**Shatin to Central Link –  
Tai Wai to Hung Hom Section**

Conservation Plan  
for the Old Pillbox  
at the former Tai Hom Village site

Further Structural Survey for the Old Pillbox

TITLE		CONTRACT 1106	
		DIAMOND HILL STATION	
		HERITAGE - PILLBOX	
		RELOCATION PROPOSED PERMANENT	
		STRENGTHENING METHOD FOR ENTIRE STRUCTURE	
SCALE	DRAWING NO.	REV.	
1 : 50 @ A1	1106/T/301/ACM/C21/504	B

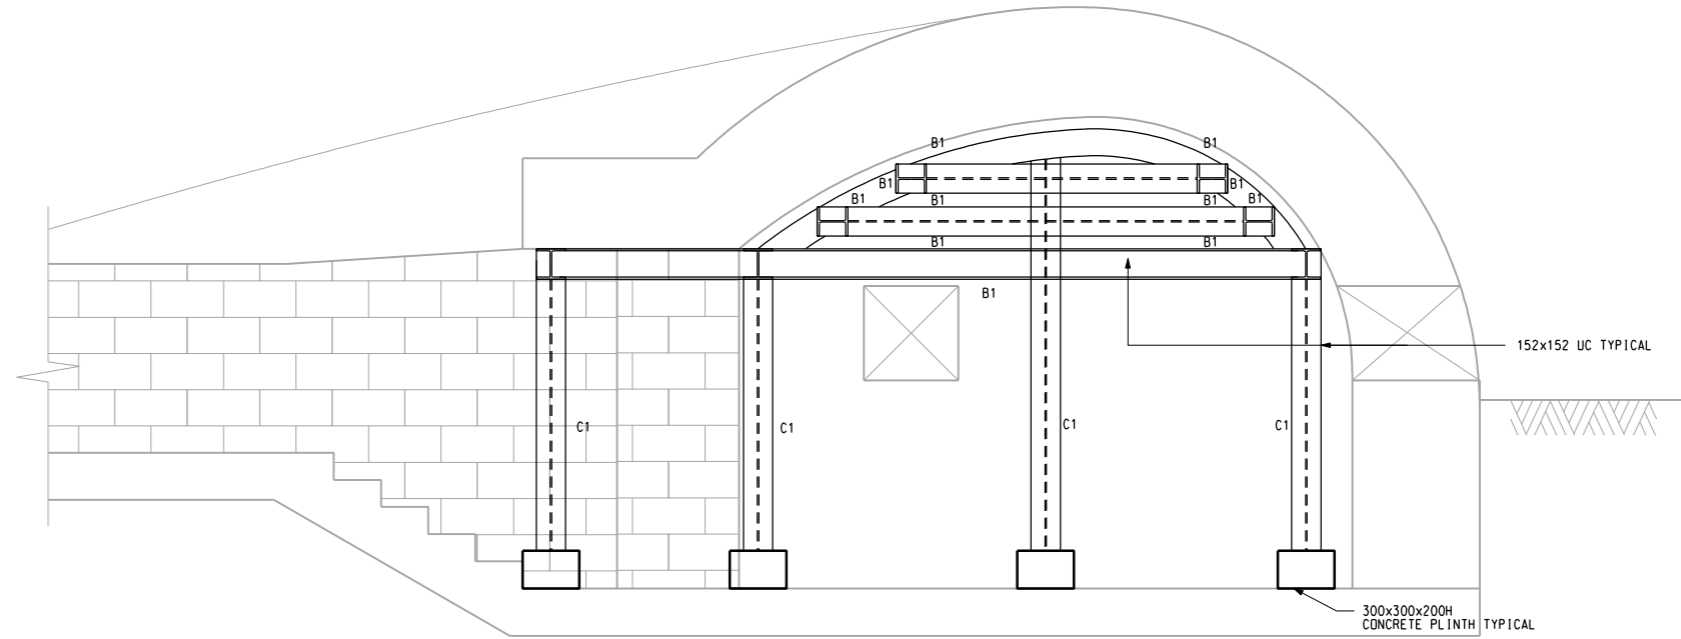
Ref	Comment	Response from MTR Corporation
14.	<p>Drawing 1106/T/301/ACM/C21/504</p> <ol style="list-style-type: none"> <li>1. It is recommended the pillbox structure shall be propped and adequately supported laterally prior to the installation of the temporary steel lifting platform.</li> <li>2. Timber packing shall be placed to prevent direct contact between steelworks and the pillbox structure.</li> <li>3. Load from the steel post shall be spread at the base to prevent excessive load onto the existing slab.</li> <li>4. Lateral loop in steel rods shall be considered to wrap round the roof dome to prevent cracking of the roof due to lateral movement.</li> <li>5. The drawing title shows permanent strengthening details. Please clarify if the details are only temporary to facilitate the relocation and all strengthening work will be removed once in the final position.</li> </ol>	<p>Additional notes have been added to drawing C21/504 to address comments 1 to 4.</p> <p>The strengthening works are proposed to be permanent to ensure structural stability of the structure after its relocation.</p>

TITLE		CONTRACT 1106	
DIAMOND HILL STATION		HERITAGE - PILLBOX RELOCATION	
UNDERPINNING		(SHEET 1 OF 3)	
SCALE	N.T.S.	DRAWING NO.	1106/T/301/ACM/C21/501
REV.	B

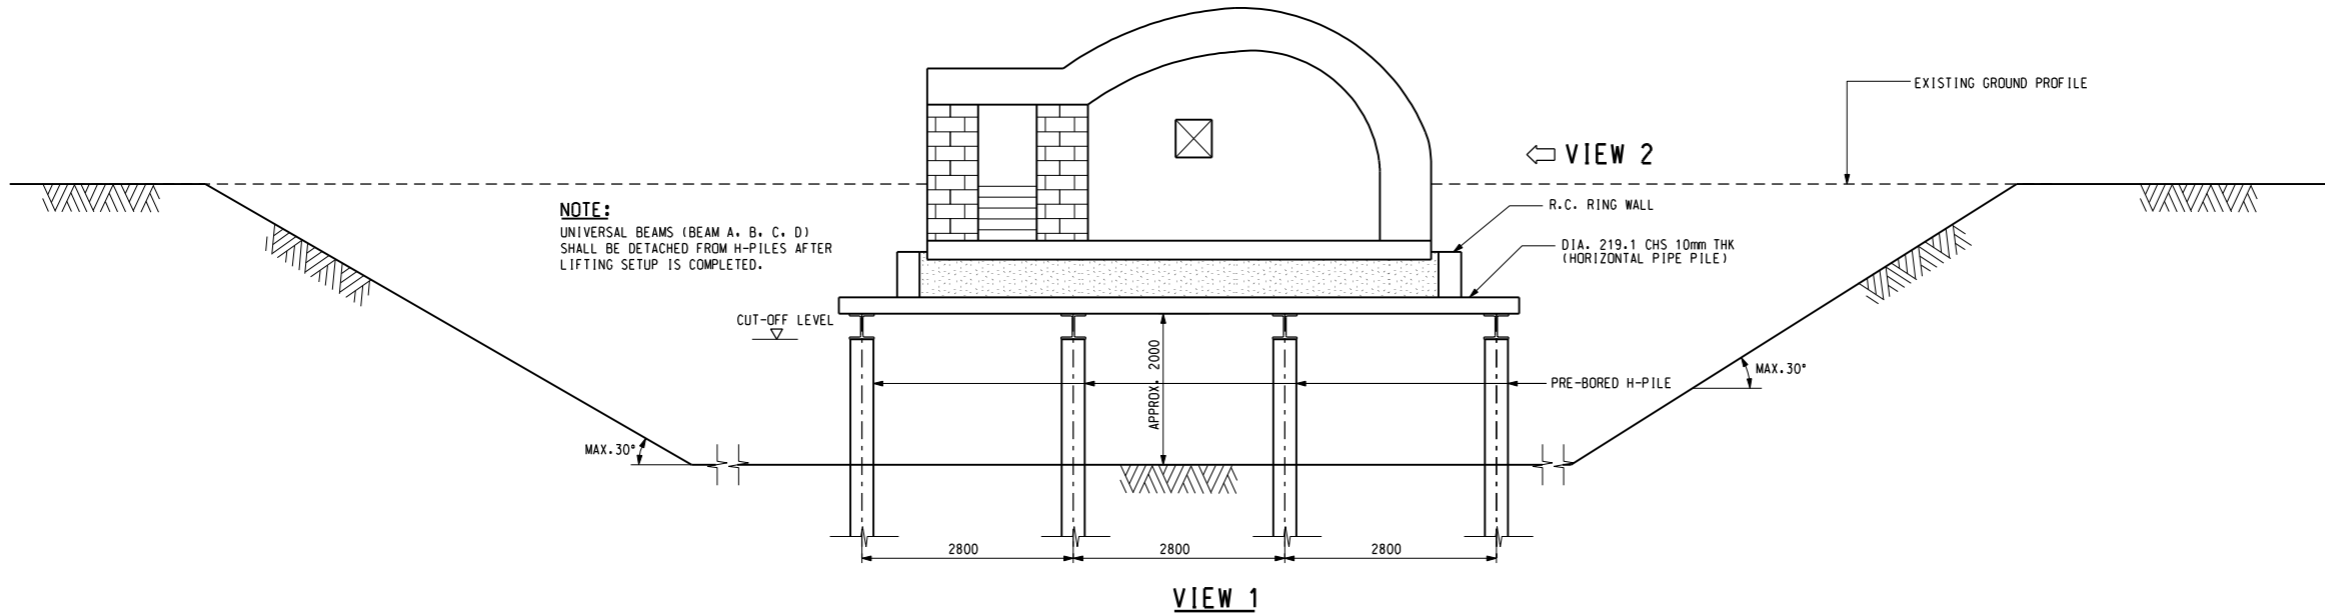
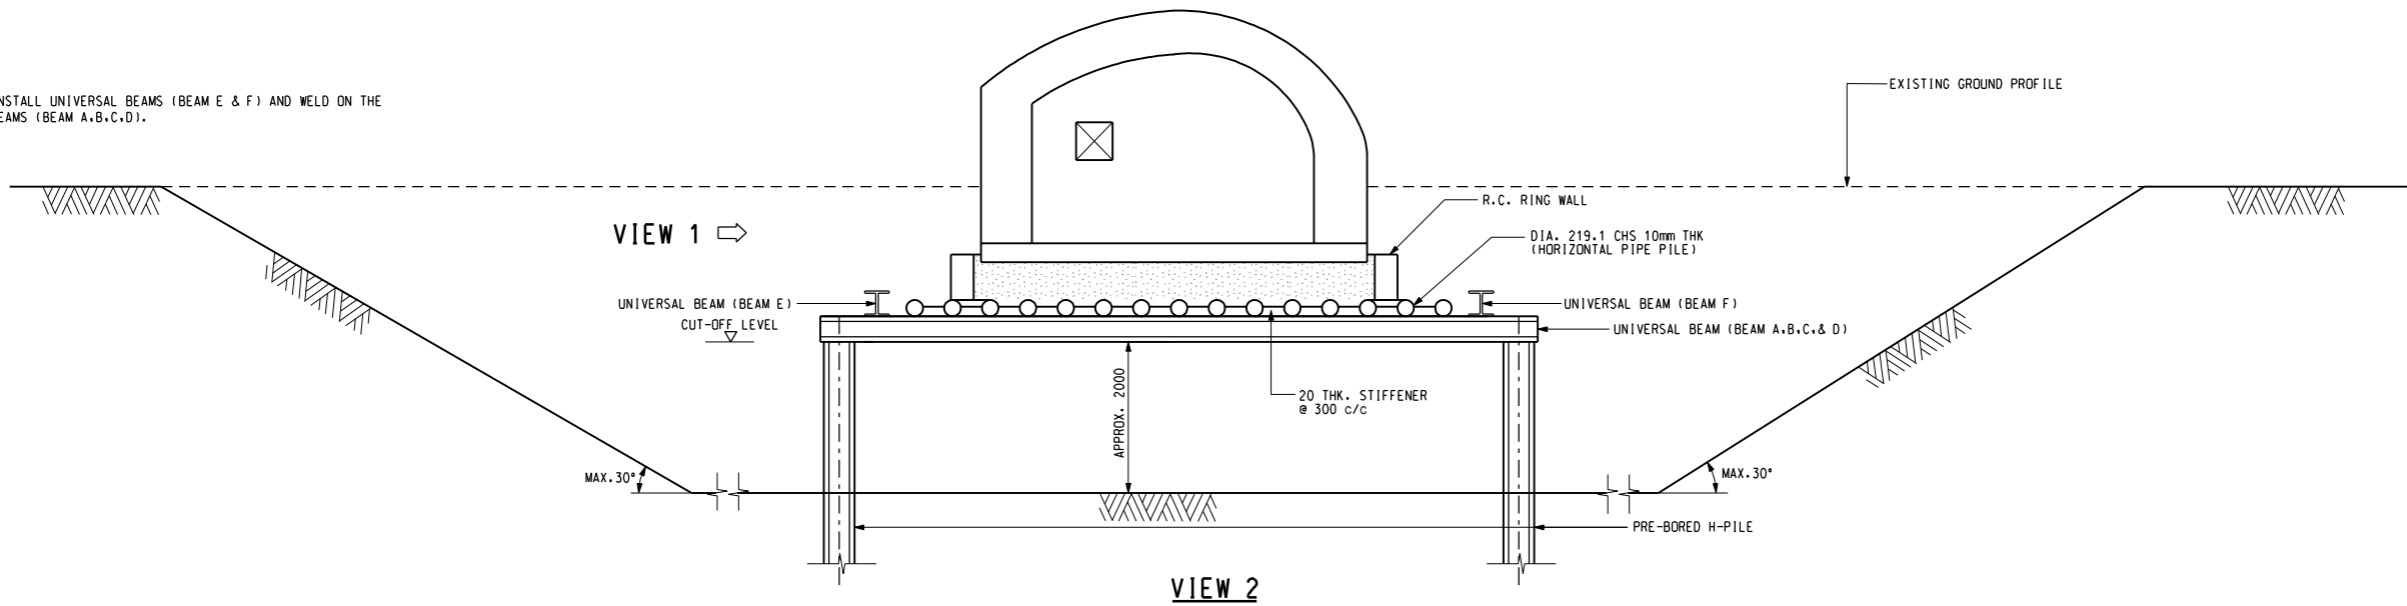
11.	<p>Drawing 1106/T/301/ACM/C21/501</p> <ol style="list-style-type: none"> <li>1. The levelled temporary steel lifting platform shall acknowledge the inclined base of the entrance steps with adequate vertical and lateral support as the RC ring wall is not able to retain the soil beneath the steps.</li> <li>2. Consideration shall be given to prevent soil escape into the side walls during the excavation of the tunnels beneath the pillbox.</li> <li>3. It is suggested the soil above the temporary steel lifting platform be consolidated with grouts.</li> <li>4. Jacking of steel H sections shall be considered in lieu of pipe piles to improve the stiffness of the temporary lifting platform as the estimated deflection during the relocation is</li> </ol>	<p>The staircase is above the base of the lifting platform, however, should this not be the case, layout of the RC ring wall can be adjusted to suit the inclined base.</p> <p>Steel lagging plates or channels can be installed progressively to prevent soil escape into the excavation.</p> <p>Grouting requires drilling horizontal holes for installation of grout tubes within the 500mm gap between the horizontal pipe piles and the Pillbox base, the drilling operation might disturb the structure. Moreover, the grout under pressure might enter into the pillbox causing potential damage to the structure. This is not recommended.</p> <p>Agreed that whilst steel H sections will improve the stiffness of the temporary platform, the jacking of the stiffer H sections will result in greater disturbance of the adjacent ground and</p>

TITLE		CONTRACT 1106	
DIAMOND HILL STATION		HERITAGE - PILLBOX RELOCATION	
UNDERPINNING		(SHEET 2 OF 3)	
SCALE	N.T.S.	DRAWING NO.	1106/T/301/ACM/C21/502
REV.	B

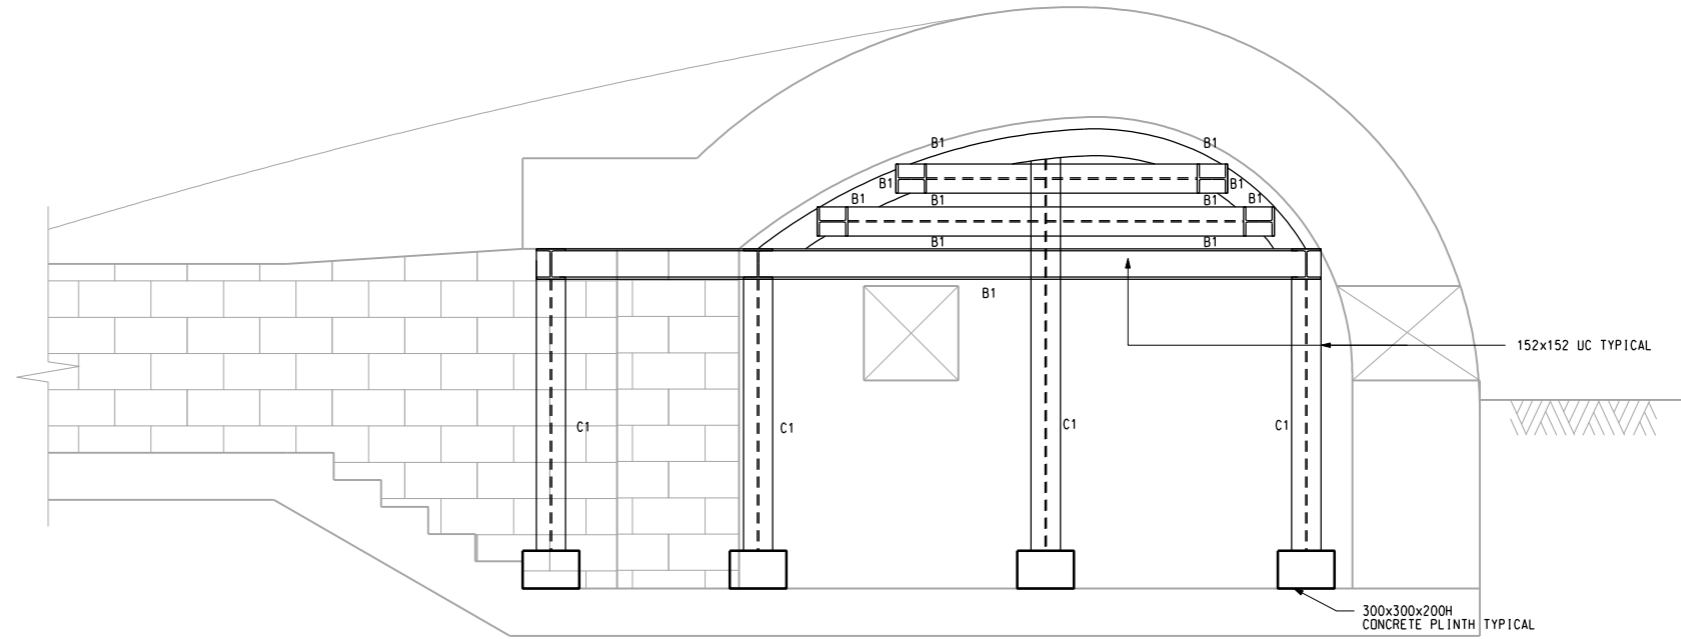
12.	<p>Drawing 1106/T/301/ACM/C21/502</p> <p>1. The 914 mm universal beams A to F shall be drawn in the true scale to reflect the right proportion.</p>	<p>Noted.</p>

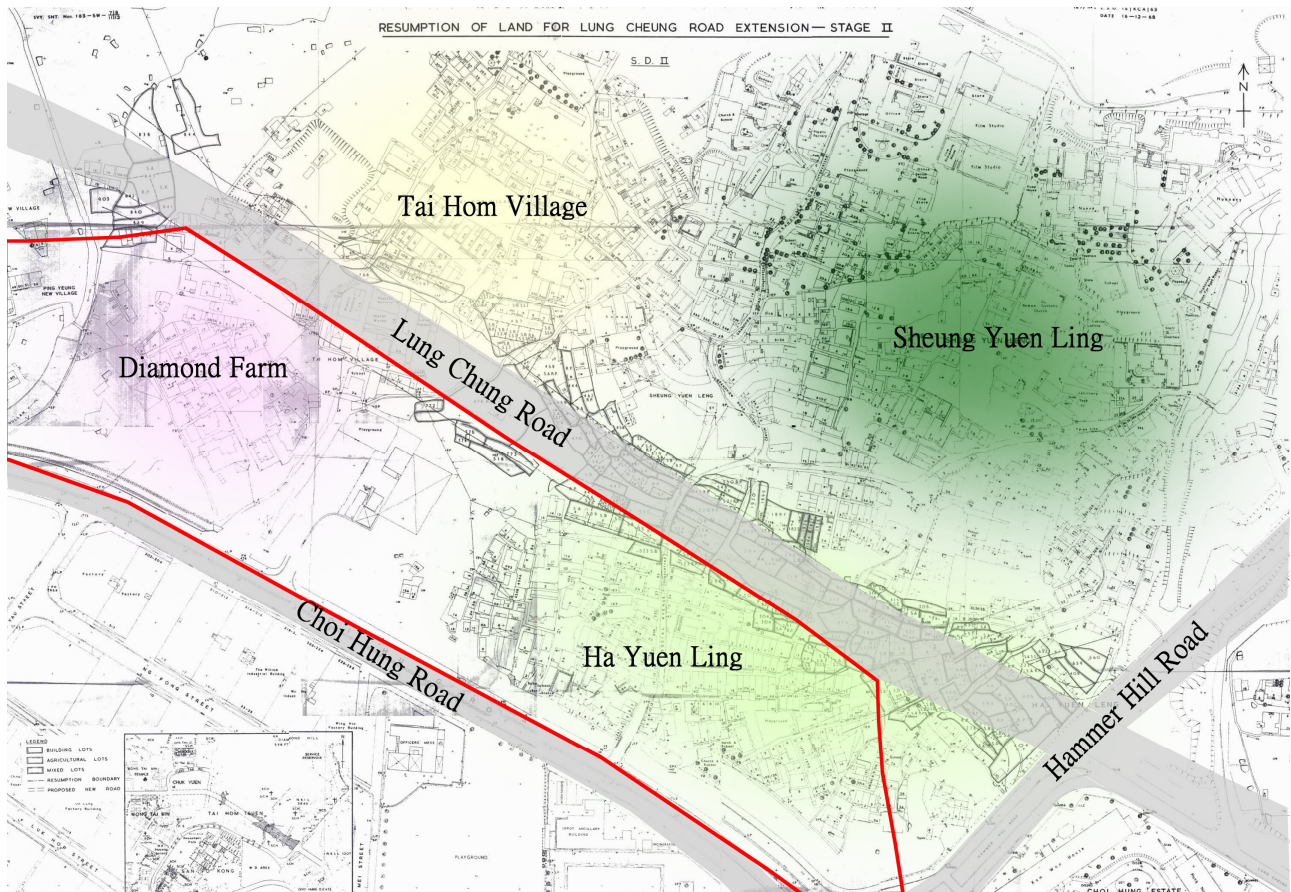
15. In Appendix I Figure a14, the red-lined area is not consistent with the description.	Noted. Amended in the revised report.
16. We understand that the demolition plan in Appendix III is conceptual only. Detailed demolition plan would be submitted to RDO and circulated for our comments.	In view of the nature of works (i.e., the Pillbox shall be relocated in one piece), Appendix III has been properly amended as Relocation Plan. The contractor has generally agreed to follow the Relocation Plan and a supplementary report with a detailed Relocation Plan will be submitted by the contractor. The contractor’s supplementary report shall be properly checked and submitted to RDO and circulated to AMO for comment.
